RAI Volume 2, Chapter 2.1.1.4, Fifth Set, Number 7:

Explain how DOE developed the nuclear safety design basis for the cask cooling subsystem identified in Table 6.9-1 of BSC, 2008bq on page 234. Examples of areas needing clarification follow:

Figure 1. Revised Model of Overpressurization of the Cask Cooling System

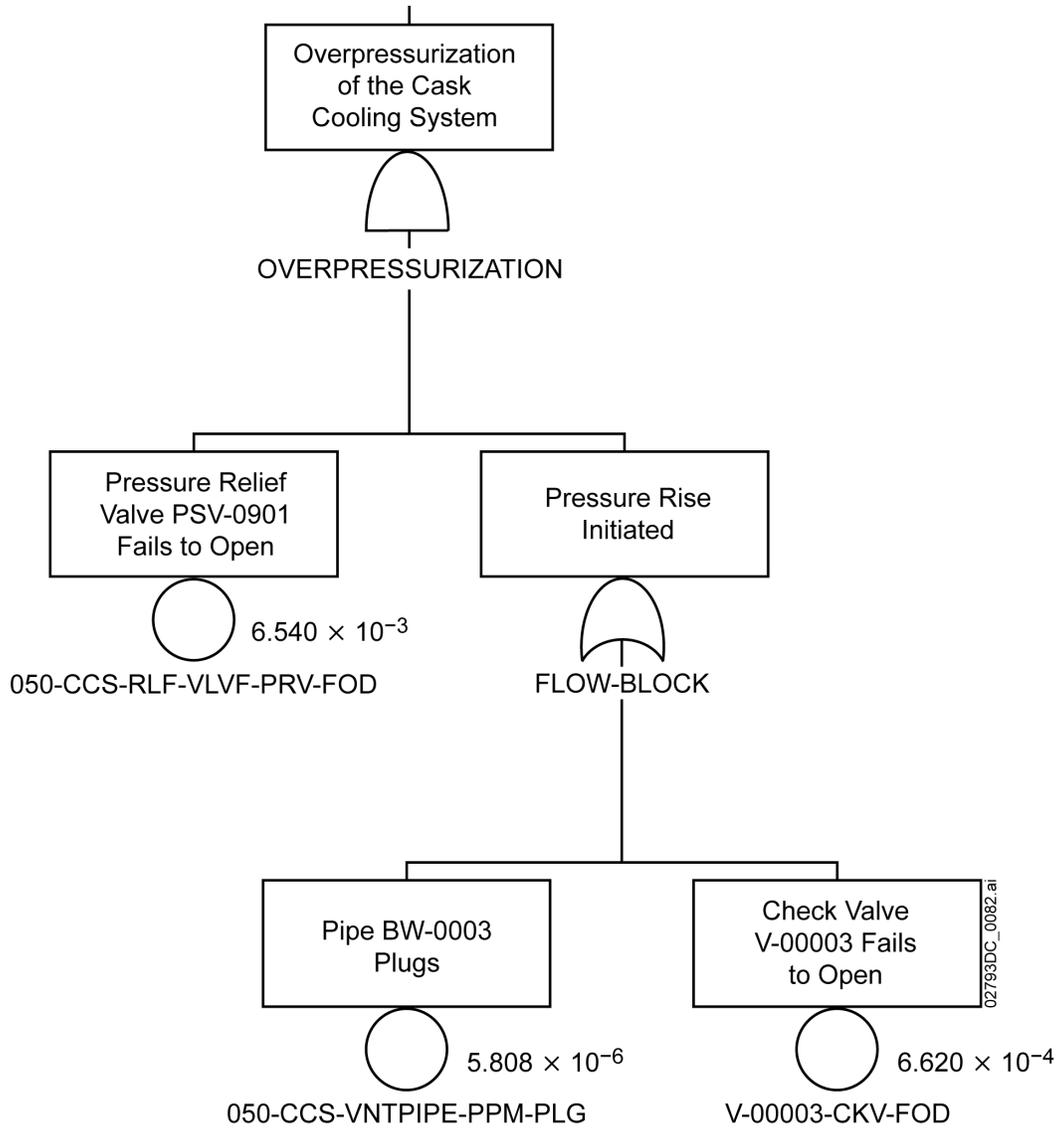
- (a) Explain if the operator error, “Operator causes overpressurization” identified as basic event 050-OPDPC-OVP01-HFI-NOW shown in Figure B5.4-8 of BSC, 2008bq is included as part of the nuclear safety design basis. The operator error is connected by an “OR” gate to the components that are part of this system.

- (b) Explain if all components that could result in an over pressurization have been accounted for in Figures B5.4-8 and B5.4-9. For example, DOE identifies failures such as pump failure and relief valve failure. DOE shows in Figure 1.2.5-69 of the SAR, the piping and instrument diagram for the Cask Cooling Subsystem. This figure also shows check valves and pressure transmitters. Explain if these other components can contribute to an over pressurization.

- (c) DOE identifies, “Pipe BW-0003 plugs” in Figure B5.4-9 of BSC, 2008bq. Clarify where this pipe is and explain if this failure accounts for all of the areas where a pipe could plug and result in an over pressurization.

In the fault tree model of the cask cooling subsystem (BSC 2009, Section B5.4.2), overpressurization was modeled as being caused by excess cooling water introduced into a heated cask or canister. Excess cooling water cannot overpressurize the system. As a result, the fault tree model of Figure 1 more accurately represents the cask/canister cooling subsystem design. The revised fault tree reflects the fact that both the vent line (shown as the vent line between the cask/canister and the gas/liquid separator vessel in SAR Figures 1.2.5-69 to 1.2.5-72) must fail to adequately pass fluid and the pressure relief valve (shown on the line from the cask/canister to the Wet Handling Facility pool in SAR Figures 1.2.5-69 to 1.2.5-72) must fail closed for the initiating event to occur. The manual valve on the vent lines will be locked open during operation; as a result, the probability of this valve failing to remain open will be dominated by random mechanical failure, which is an order of magnitude or two lower than the check valve failure probability. Operator error that results in inadvertent valve closure was not modeled for locked open manual valves.

Solving the Figure 1 fault tree results in a top event probability of 4×10^{-6} . This probability is less than the value stated as a nuclear safety design basis for the cask cooling subsystem, 8×10^{-6} (SAR Table 1.9-4). Therefore, the categorizations of cask overpressurization event sequences are not changed using this revised fault tree model.

The following components on the inlet side of the cask or canister have been modeled in the categorization analysis document (BSC 2009): the cooling water feed pump, the digital control system (through a spurious signal demanding excessive flow from the pump), and the pressure relief valve. The model in Figure 1 does not include the spurious signal from the digital control system because, as noted in Section 1, overpressurization cannot be caused by excessive flow from the cooling water feed pump.

thereby allow pressure to build up within the cask or canister. The revised model includes the check valve. Because the manual ball and butterfly valves are in the vent line, normal operating procedures would ensure that they are locked open during operation.

Because the probability that the normally locked open valves would be inadvertently left closed (conservatively, 1×10^{-5}), and the probability that manual valves (BSC 2009, Attachment H SAPHIRE model basic event DMP-FRO [8.4×10^{-8}]) would fail closed are lower than check valve failure probabilities (BSC 2009, Attachment H SAPHIRE model basic events CKV-FOD [6.6×10^{-4}] and CKV-FTX [2.2×10^{-3}]), they are not modeled in Figure 1.
